ADDENDUM NO. 1

GMIA, PARKING STRUCTURE RELIGHTING PHASE 2

PROJECT NO. A096-10012

DATE OF ADDENDUM: October 6, 2015

SHEET NO.
 PS-A1.13-1

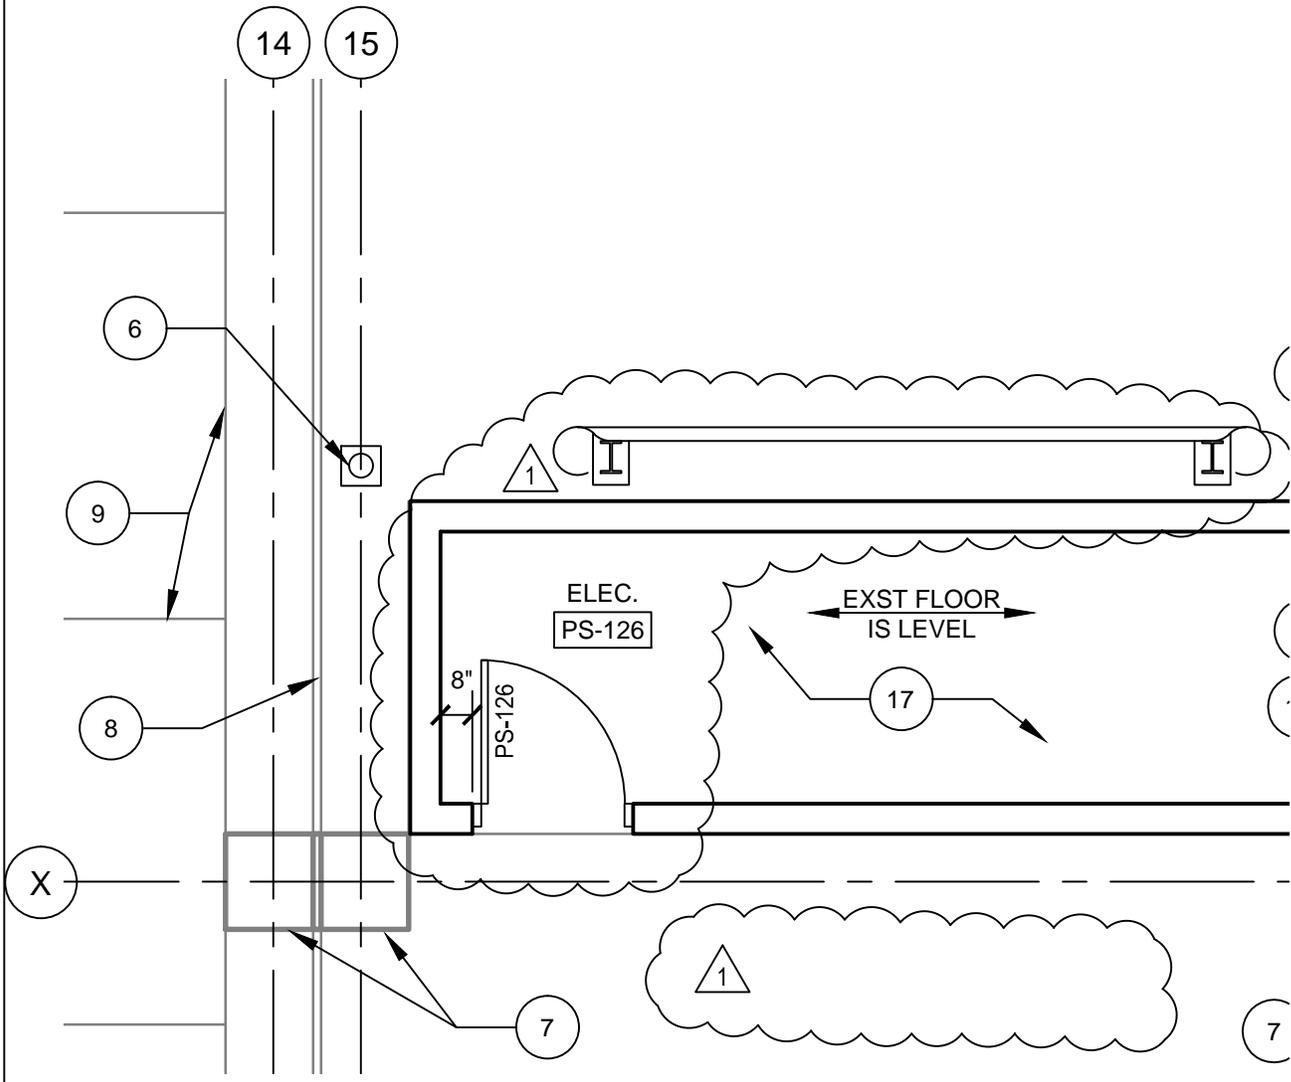
Change: Detail 1

Revise door location and swing direction per attached sheet PS-A1.13-1. Move traffic barrier to north side of room.

SHEET NO.
PS-A1.13-2

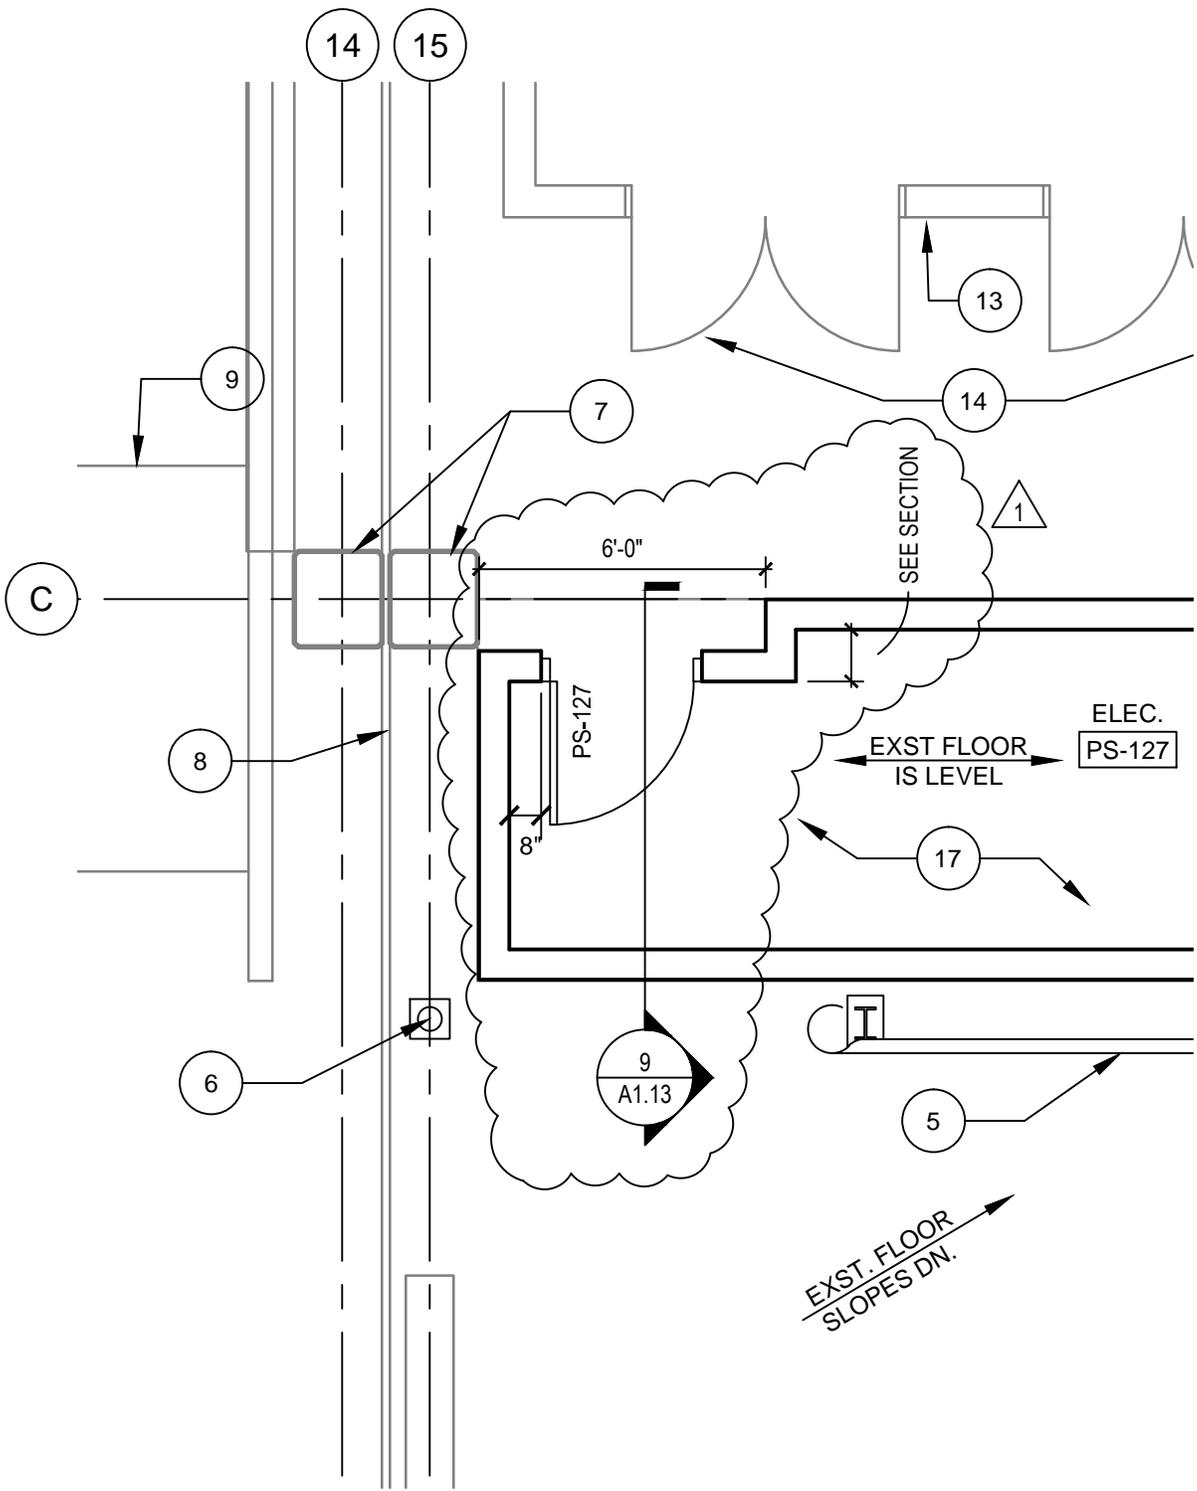
Change: Detail 2

Revise wall layout, door location and swing direction per attached sheet PS-A1.13-2.

SHEET NO.
 PS-A1.13-3

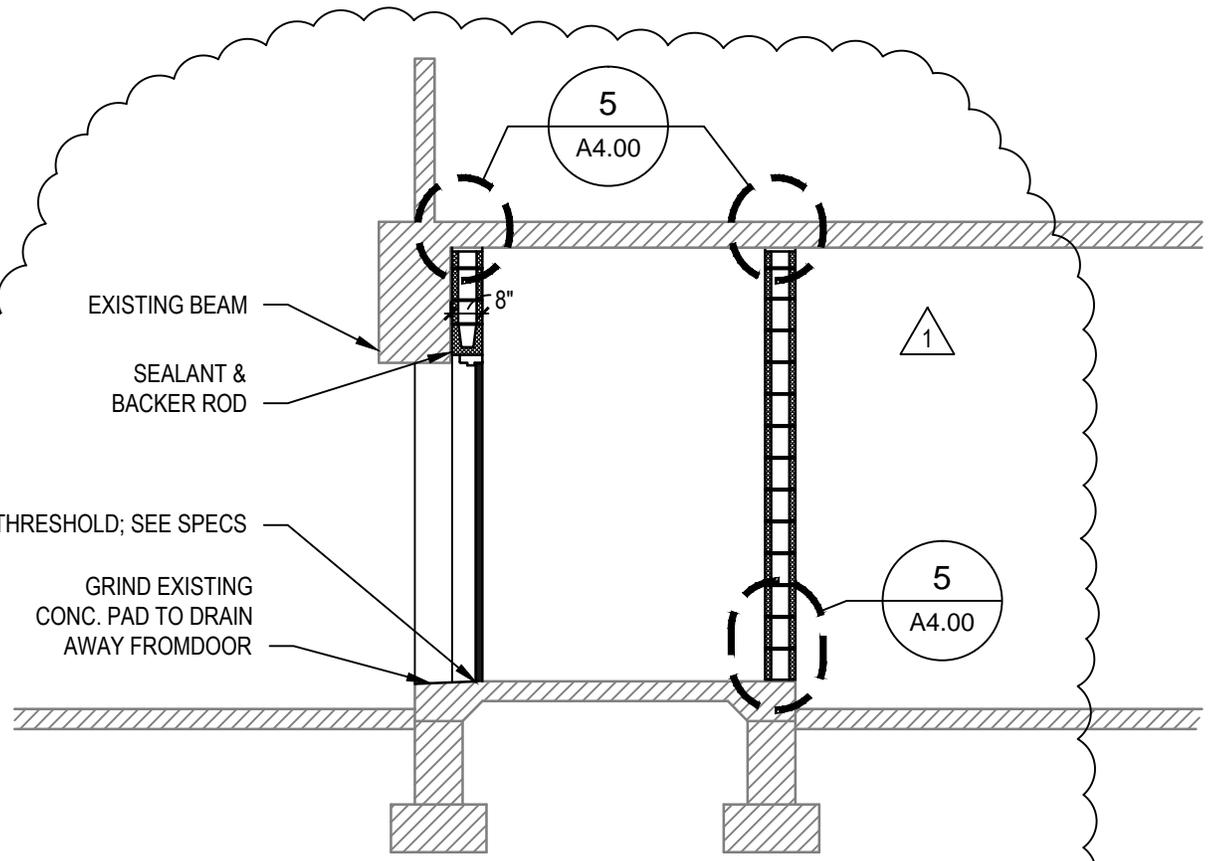
Add: Detail 9 per the attached sheet PS-A1.13-3
